FINAL PLAT LOT 1, BLOCK 1 CROSSINGS ADDITION

SITE PLAN		DATE 12/1/90	
HIGHWAY 205		T. WALTERS	
ROCKWALL, TEXAS		R212P000 DWG. ROTATED 60°00'	
SCALE 1"= 20'		JOB NUMBER 0	
SITE		REV.	
P1		0	
4-11111111 02

RACETRAC SITE PLAN - SH 205 NORTH OF IH-30 AND LAKESIDE CHEVROLET

Agenda Item: P&Z 91-1-CUP/SP/FP - Hold Public Hearing and Consider Recommending Approval of a Request From Racetrac, Inc., for a Conditional use Permit for a Building Not Meeting Materials Requirements and Approval of a Site Plan and Final Plat for a Self Serve Gas Station Located on SH-205 North of I-30

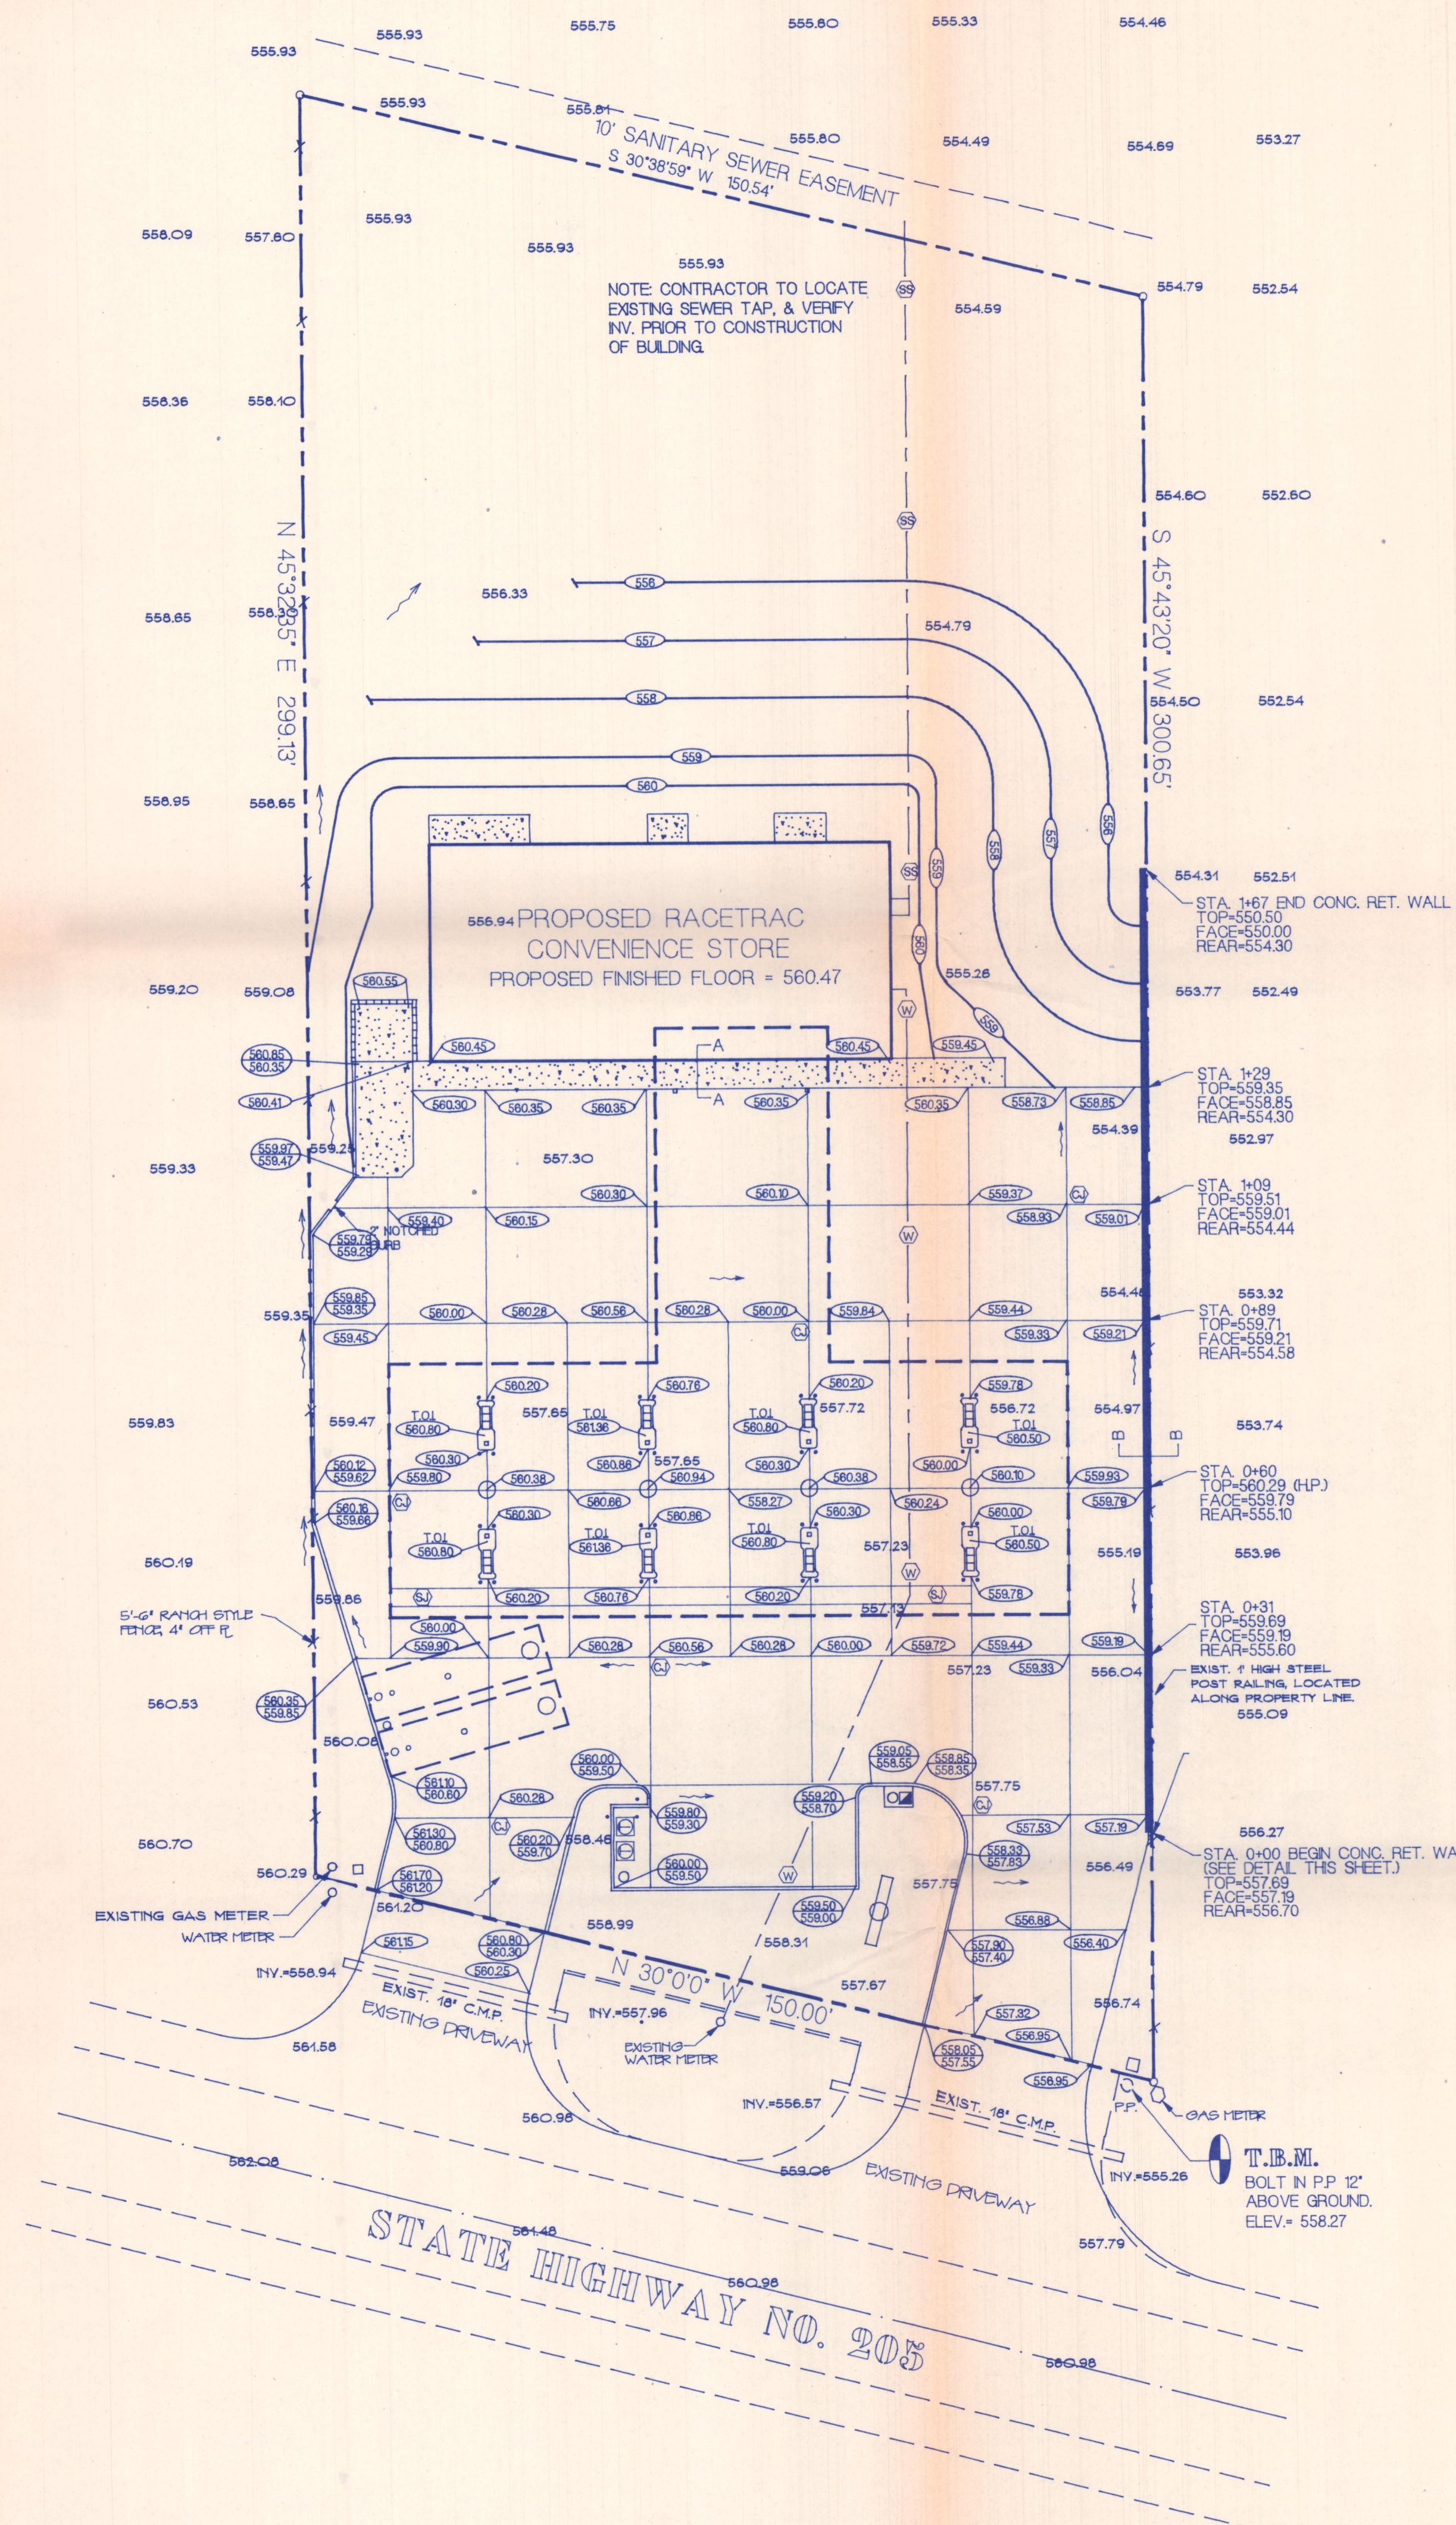
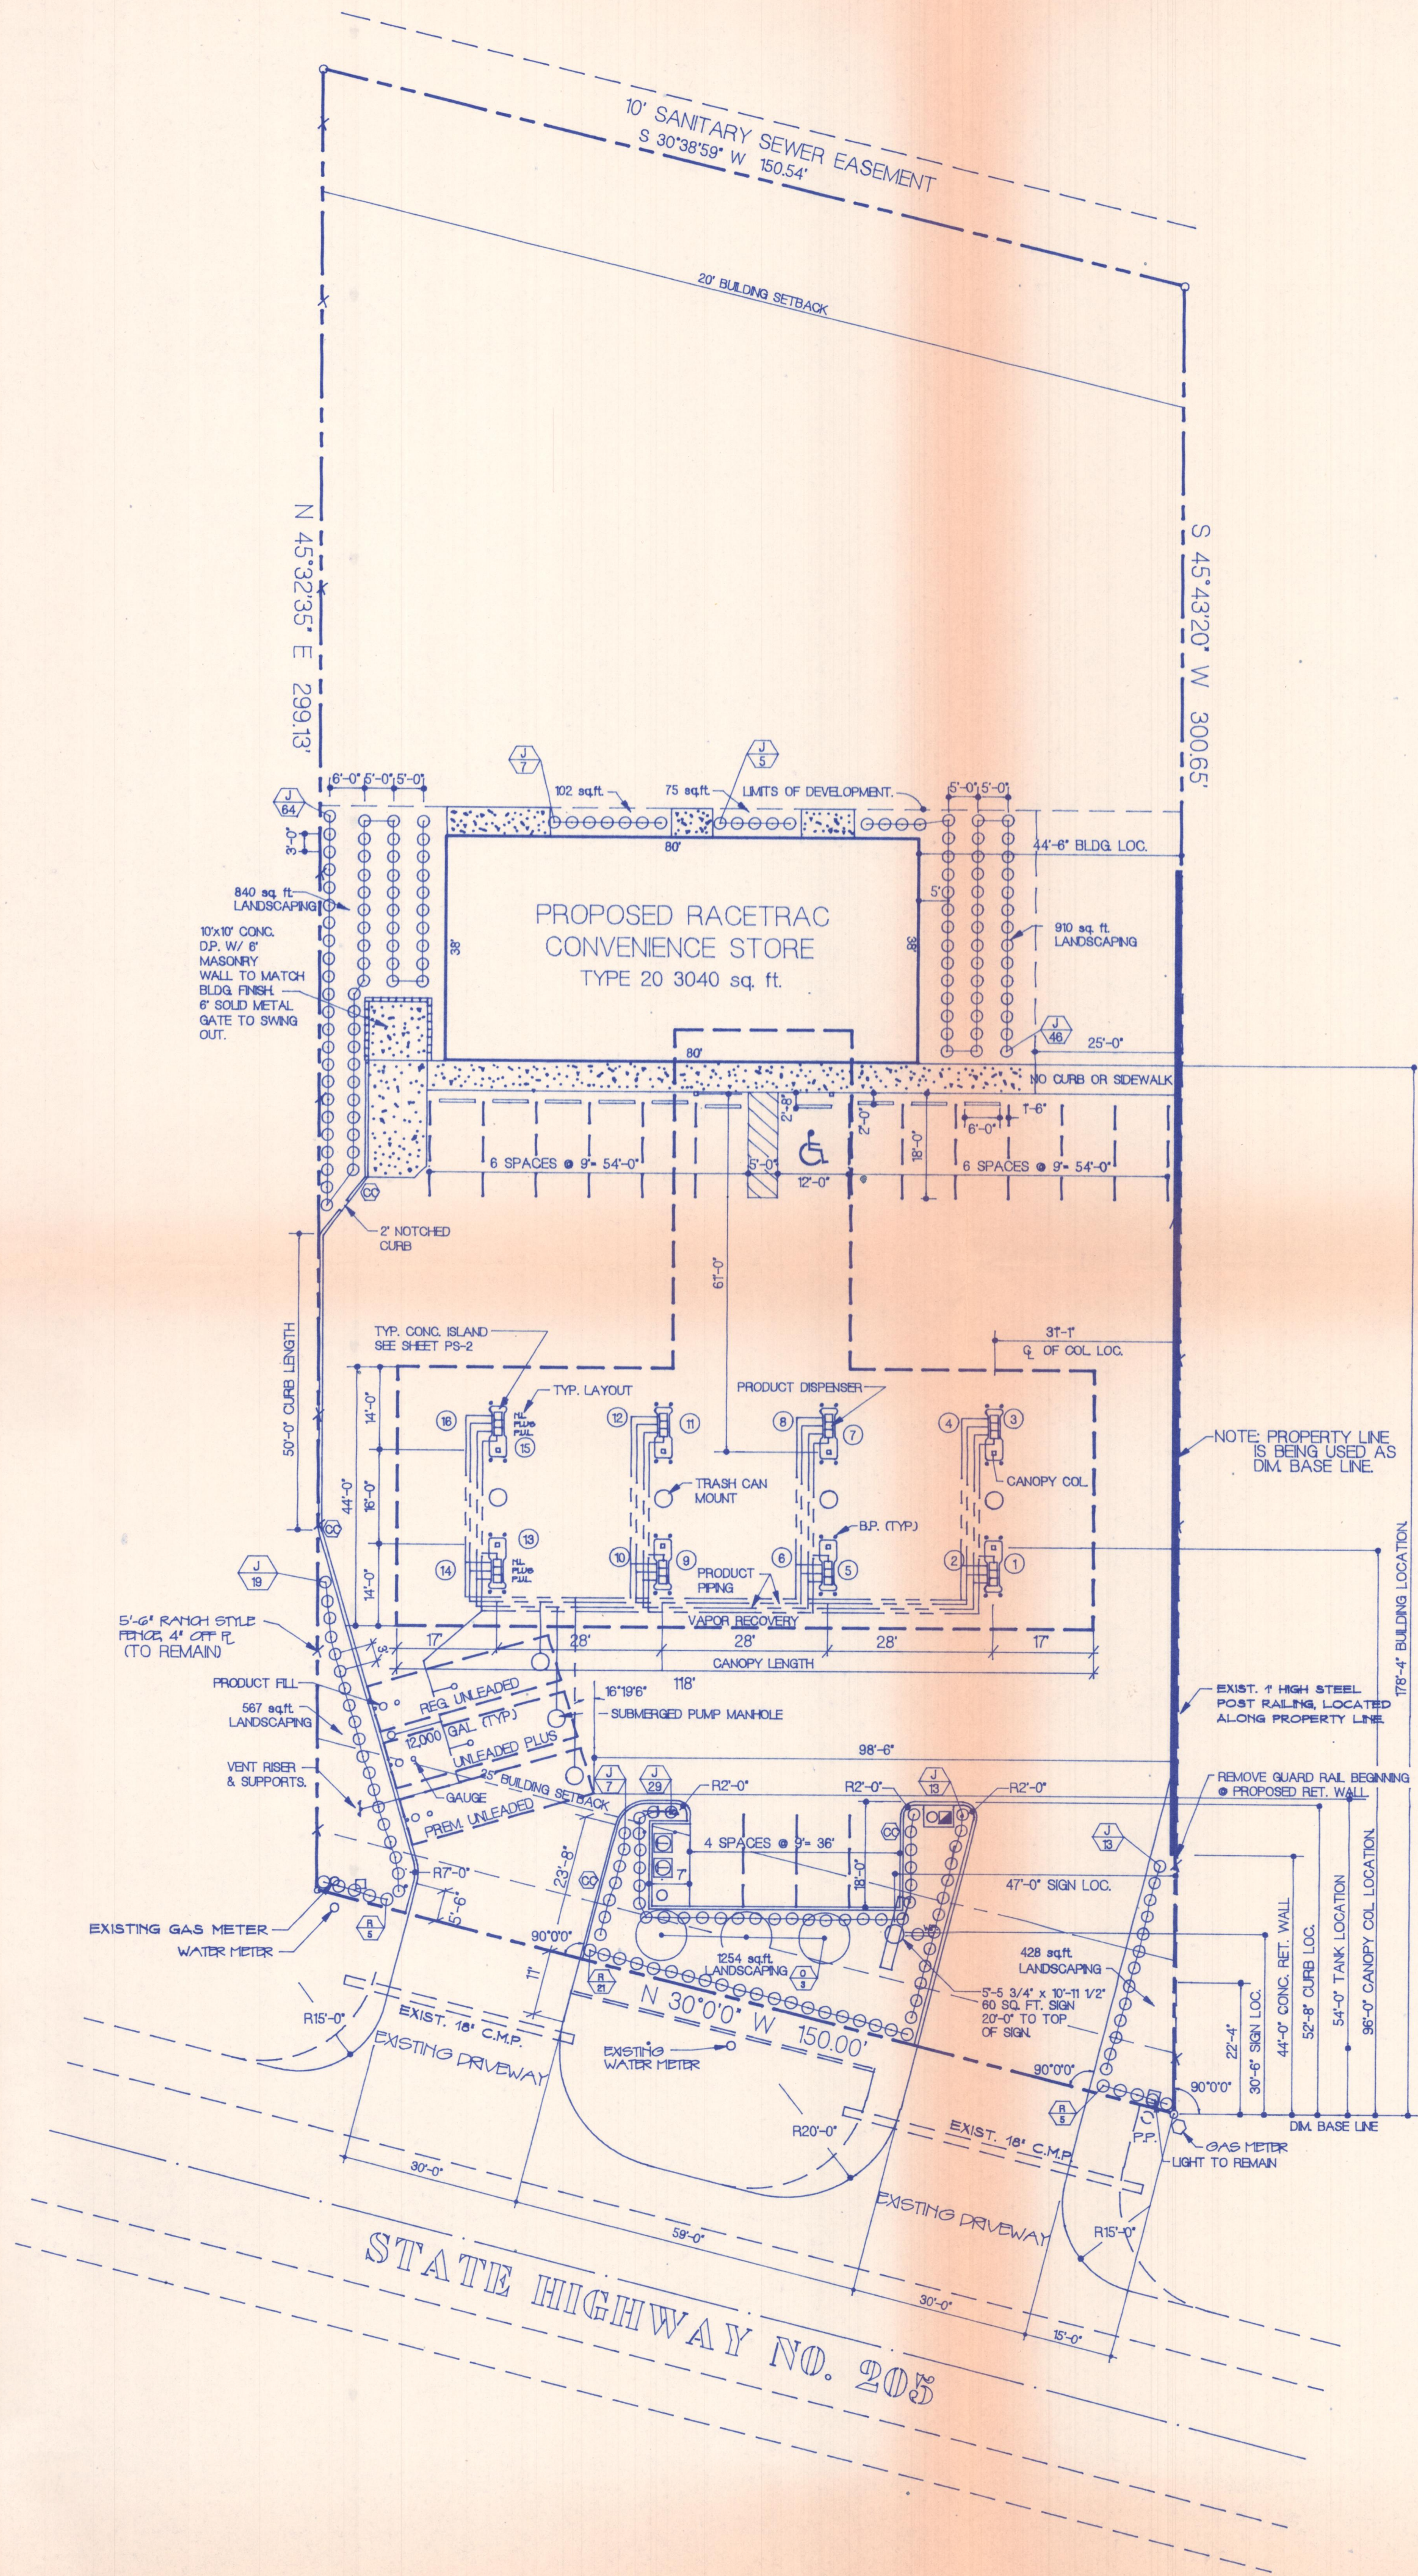
d. ^{row} area in front of the prop needs to be grassed -
show on plans.

13. Reduction of openings or reduce to one - need to show proximity of adjacent drives
14. Buddy square footage & dimensions?
15. 16 parking spaces - where are the 15 spaces
16. Elevation + color of signage + canopy
17. Nearest fire hydrant location
18. Possible ROW dedication

1. Overall, the site plan is well-conceived. Access to the pump islands, the underground tanks, and the convenience store parking is good.
2. There should be a designated access easement along the south side of the property to access the land east of this site.

3. The radii at each proposed driveway encroach upon the neighboring properties to the north and south. In order to correct this, three things could be done - reduce the driveway widths from 30 to around 24 FT, move the driveways inboard to the property thereby reducing the 68 FT clear space between driveways, and reduce the size of the radii. A small reduction of each of these factors would eliminate the encroachment problems without unduly sacrificing the site plan.

4. The site plan shown includes two driveways. City standards identify driveways for a site to be generally separated by distances of 150 FT. The plan shown, however, is a good one, and the site may have access in the future to a median opening at the north property line. The plan as presented seems best.

5. Some consideration should be given to setting up cross-access easement capability to the properties north and south of this site. While these adjoining properties may not want to take advantage of such easements at this time, there will come a time when SH 205 will have a raised median. It seems in the best interests of the City to require cross-access easements along major thoroughfares as a general means of helping to provide for future vehicular movement.

1. Require applicant to show joint access easement to the property east of this site.
2. Require applicant to show an access easement across the property, north-south, for the future potential use of the adjoining properties.
3. Eliminate the encroachment of the applicant's curb return radii onto adjoining properties.
